Staff Report & Recommendation

Historic Preservation Board

SUBJECT: HPB23-0575, **100 Block of Lincoln Road Right-of-Way and 1 Lincoln Road.**

The applicant has submitted plans entitled “Lincoln Road – 100 Block”, as prepared by Kobi Karp Architecture and Interior Design, Inc., dated November 13, 2023.

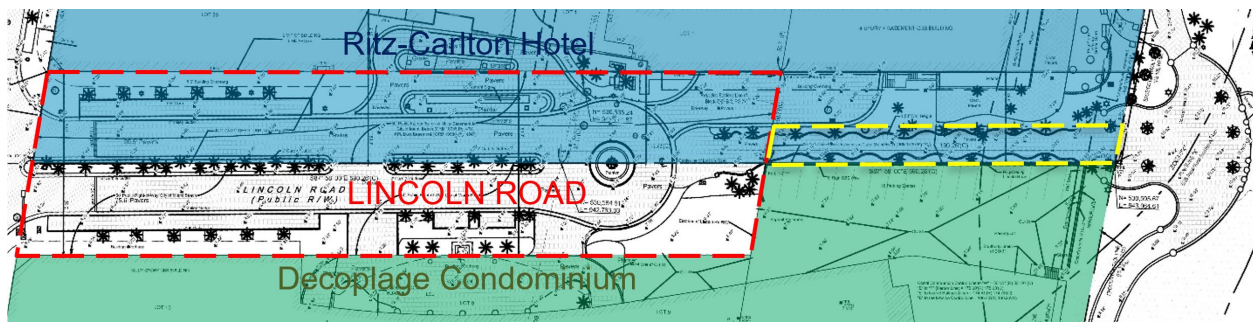
Staff would preface this analysis by noting the unique ownership conditions of the portion of Lincoln Road east of Collins Avenue. As can be seen in the diagram below, the northern half of what is recognized as Lincoln Road (red) is actually part of the Ritz-Carlton Hotel property (blue). Additionally, the northeastern corner of the Decoplage Condominium (green) property extends north to meet the Ritz-Carlton property. In order to provide access to the Beachwalk, the City has a 20'-0" wide pedestrian access agreement (yellow) within the southeastern corner of the Ritz-Carlton property.

The subject application is limited to improvements to Lincoln Road, including the portion owned by the Ritz-Carlton and the pedestrian easement area (the areas outlined in red and yellow). Improvements include the reconfiguration of the roadway and sidewalks, the introduction of decorative paving and enhanced landscaping. Additionally, the applicant is proposing to modify the Ritz-Carlton Hotel drop off area including the widening of the pedestrian walkway along this portion of the building and the introduction of a new driveway and loading area configuration.
